12th January 2024

Low Carbon Emission Blacktown City Draft Plan Feedback

Snippet of Central River City Priority Connections, With Green connection across Blacktown listed as an 'Immediate Opportunity for Investigation'.

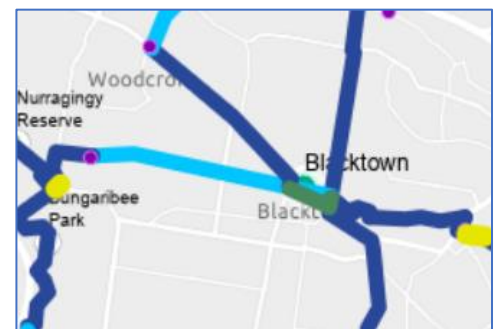
Getting across Blacktown from Richmond Rd to Main St safely and legally (without dismounting from the bike and walking sections) for all but the most confident riders is pretty much impossible. Having said that, we do acknowledge that this has been identified in the Central River City strategy^[6] as a missing link and look forward to a satisfactory and safe outcome for all riders.

Depending on the solution adopted, this may or may not help riders get into the Blacktown CBD. (We like the idea of building a cantilever on the western side of the Richmond Rd railway bridge and a dedicated cycle lane on the northern side of Main St – but there may be practical barriers to implementing this suggestion).
